TRANS/WP.29/GRSP/2001/14/Rev.1
28 February 2002

World Forum for Harmonization of Vehicle Regulations (WP.29)

Working Party on Passive Safety (GRSP)
(Thirty-first session, 13-17 May 2002,
agenda item 2.)

PROPOSAL FOR DRAFT 06 SERIES OF AMENDMENT TO REGULATION No. 14
(Safety-belt anchorage)

Figure 1: Static force application device (S-FAD), isometric views

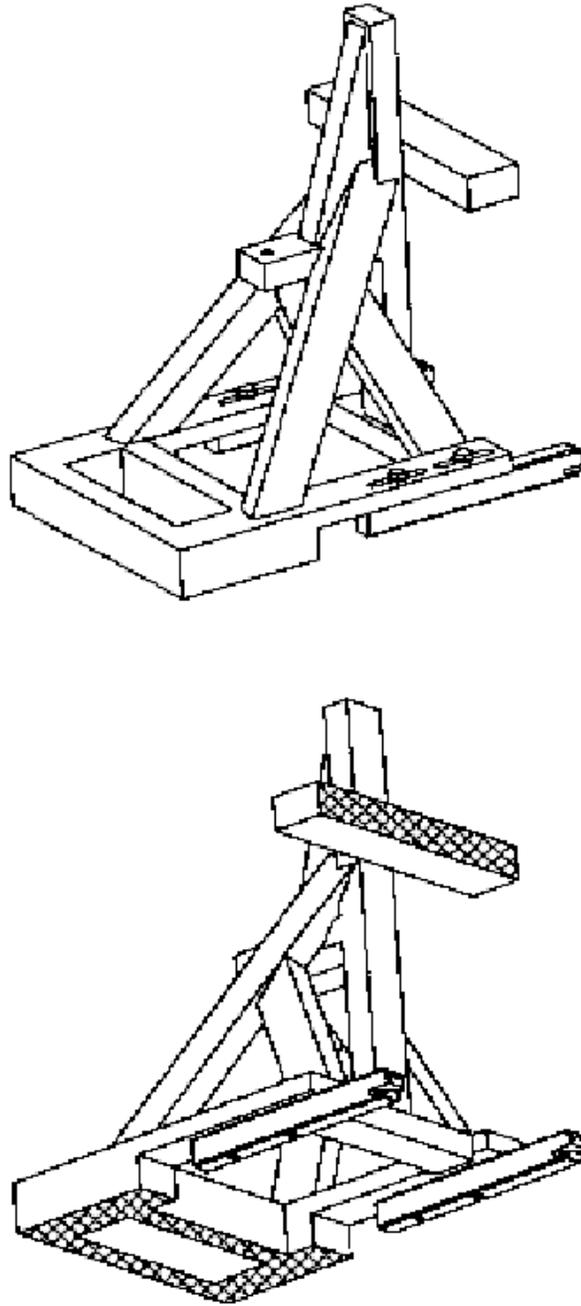
2.22. "Static force application device (S-FAD)" means a test fixture that engages the vehicle ISOFIX anchorages systems and that is used to verify their strength and the ability of the vehicle or seat structure to limit the rotation in a static test. The test fixture is describe in the figures 1 and 2.

The S-FAD is made of steel, mild steel rectangular tubing 50 mm by 75 mm of 3 mm nominal thickness, with 6 mm thick force application test device attachment point plate. Securely welded construction.

Figure 4: Distance between both low anchorage zones

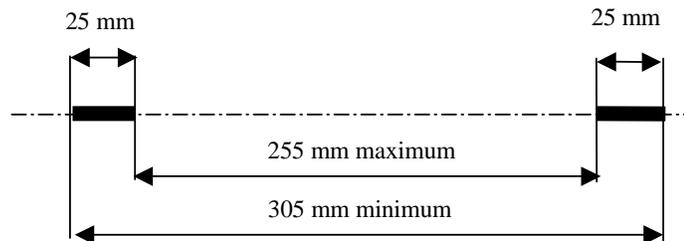
5.2.3.1. Any ISOFIX anchorages system shall be 6 mm ± 0.1 mm diameter transverse horizontal rigid bar(s) which cover(s) two zones of 25 mm minimum effective length located on the same axis as defined in figure 4.

Figure 6: ISOFIX Top tether anchorage location, ISOFIX zone - Enlarged side view of wrap-around area

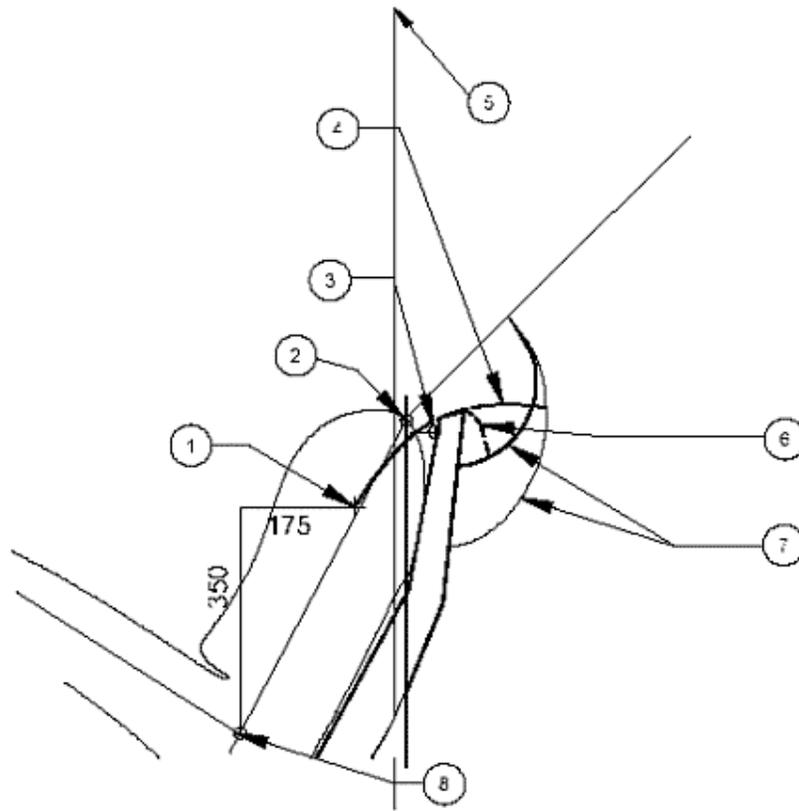
- 5.2.4.1. Subject to paragraph 5.2.4.3. the portion of each top tether anchorage that is designed to bind with a top tether connector shall be located within the shaded zone - as shown in figure 5 to 10 - of the designated seating position for which it is installed, with the reference of a template described in annex 4 of this Regulation, if,

Figure 10: Alternative method of locating the top tether anchorage using the ISOFIX Child Restraint Fixture, ISOFIX zone - Side and plan views"

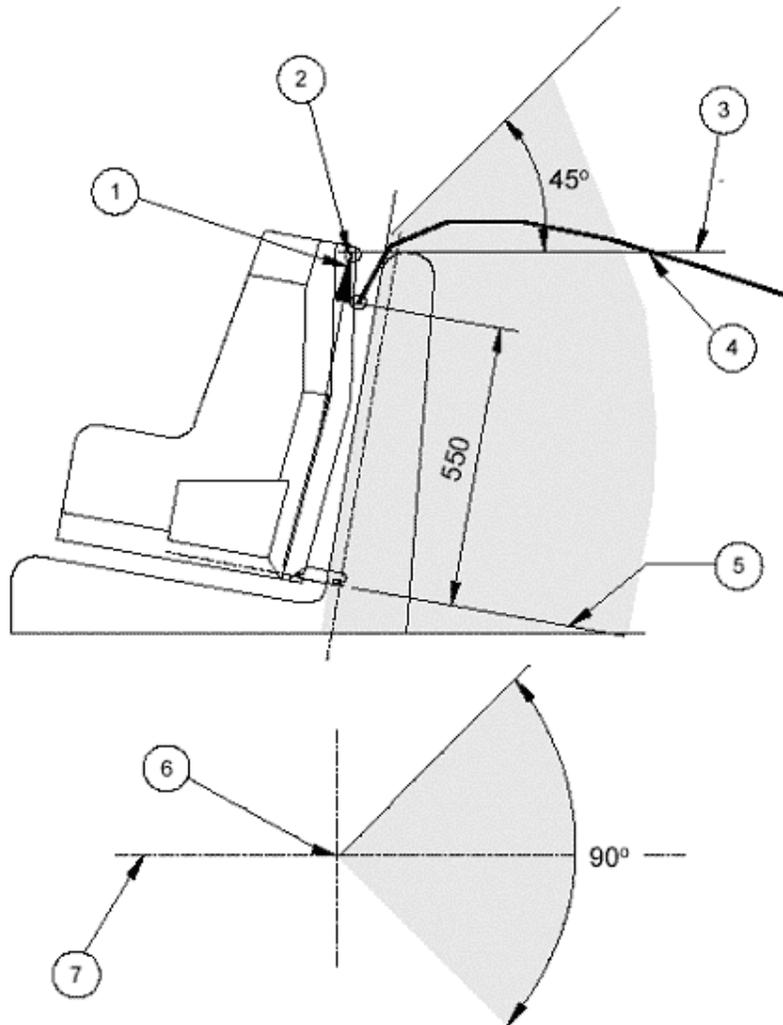
- 5.2.4.2. The ISOFIX top tether anchorage zone may be alternatively located with the aid of the Fixture "ISO 2", as defined in Regulation No. 16, in an ISOFIX position equipped with ISOFIX low anchorages as shown in figure 10. In the side view, the top tether anchorages shall lie behind a lateral plane containing the Fixture "ISO 2" vertical reference line and probe and below a lateral plane passing through the intersection of the "ISO 2" fixture reference line and the plane containing the underside of the seat top bar, and extending rearward at an angle of 45° above the horizontal.

- In the plan view, the top tether anchorage zone shall lie between the planes extending rearward and laterally from the tether reference point, and separated by an angle of 90°. Further, the ISOFIX top tether anchorage shall be more than 200 mm but not more than 1000mm from the origin of the top tether strap on the rear face of the "ISO 2" fixture, measured along the strap when it is drawn over the seat back to the anchorage.
